Access Report – Concept Design NCC/BCA 2022 – Volume 1, Amendment 2

Garden Suburb

Lot 67 & Lot 68 Myall Road, Hillsborough NSW 2289

Prepared for: Landcom
Our Ref: 25000313 | Issue date: 17 October 2025

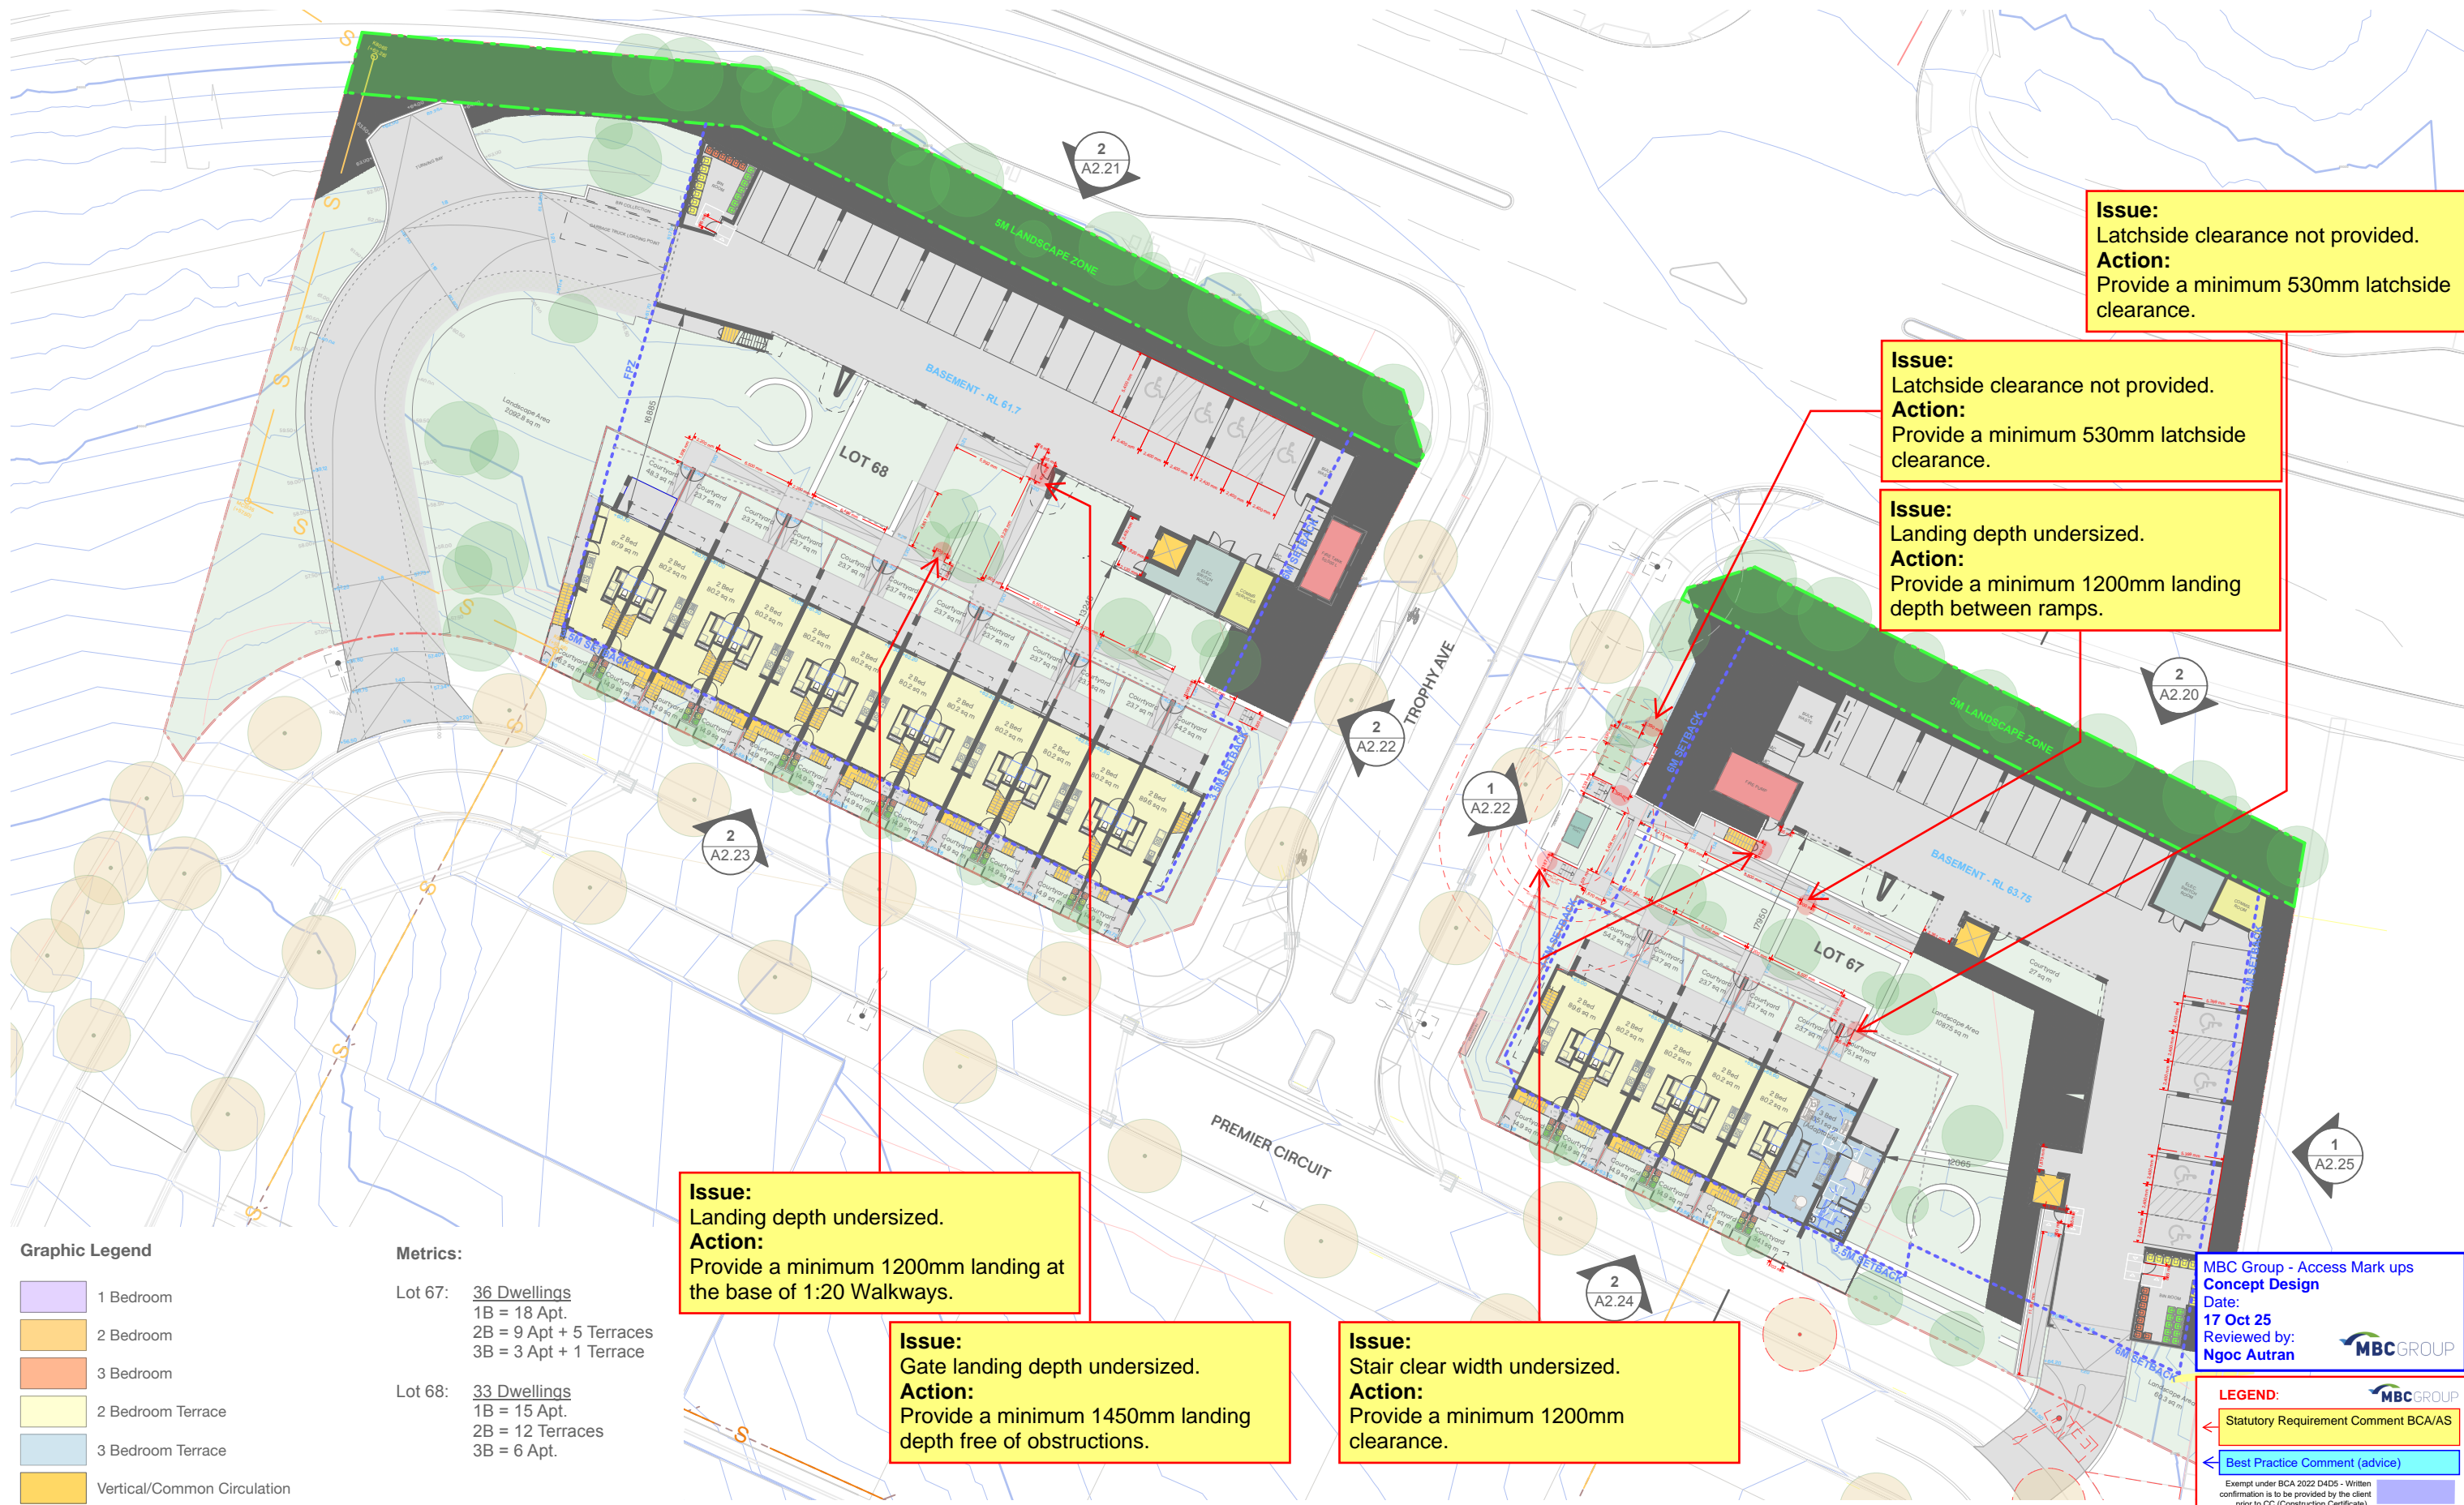
Issue:
Latcheside clearance not provided.
Action:
Provide a minimum 530mm latcheside clearance.

Issue:
Latcheside clearance not provided.
Action:
Provide a minimum 530mm latcheside clearance.

Issue:
Landing depth undersized.
Action:
Provide a minimum 1200mm landing depth between ramps.

Issue:
Landing depth undersized.
Action:
Provide a minimum 1200mm landing at the base of 1:20 Walkways.

Issue:
Gate landing depth undersized.
Action:
Provide a minimum 1450mm landing depth free of obstructions.

Issue:
Stair clear width undersized.
Action:
Provide a minimum 1200mm clearance.

2 3 Bedroom Terrace - Lot 67; Ground Floor
Scale: 1:100

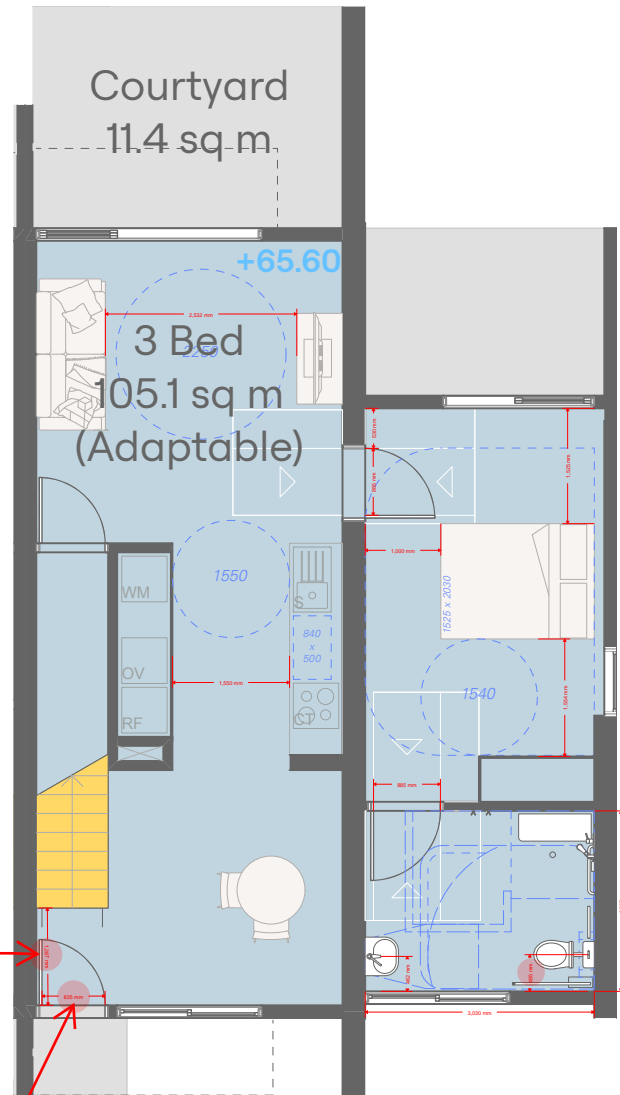
Issue:
Door landing depth undersized.
Action:
Provide a minimum 1450mm landing depth.

Issue:
Door clear opening undersized.
Action:
Provide a minimum 850mm door clear opening width.

1 2 Bedroom Apartment- Lot 67; Ground Floor & Level 1 & 2
Scale: 1:100

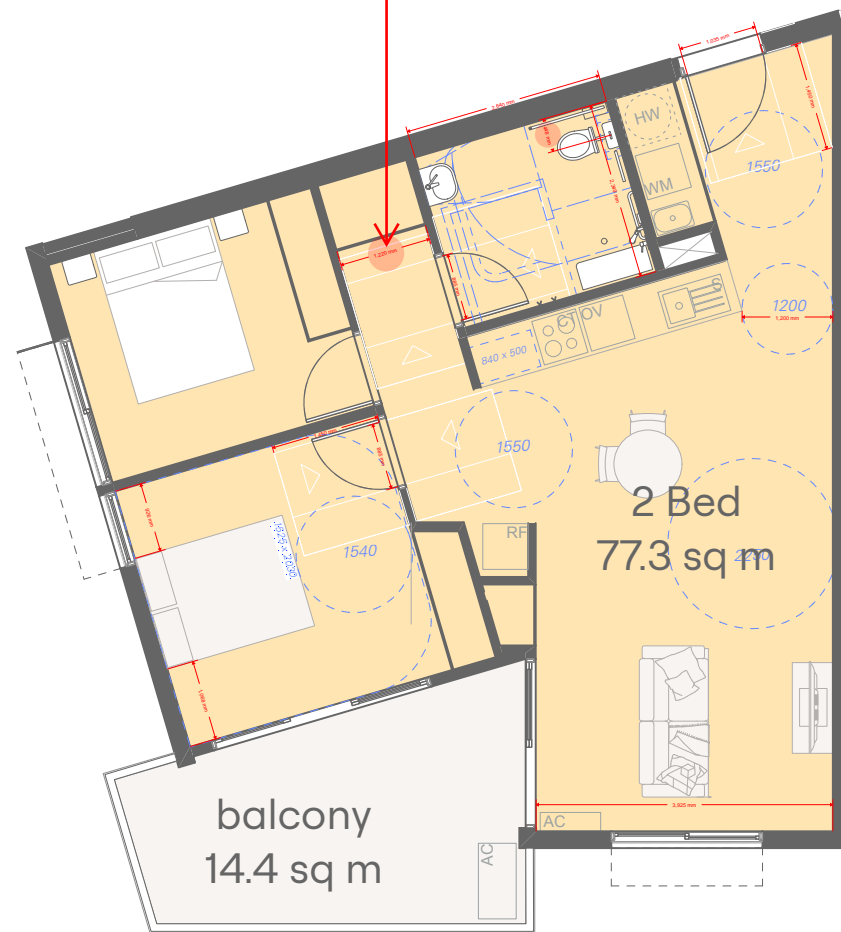
Issue:
Door landing depth undersized.
Action:
Provide a minimum 1240mm landing depth.
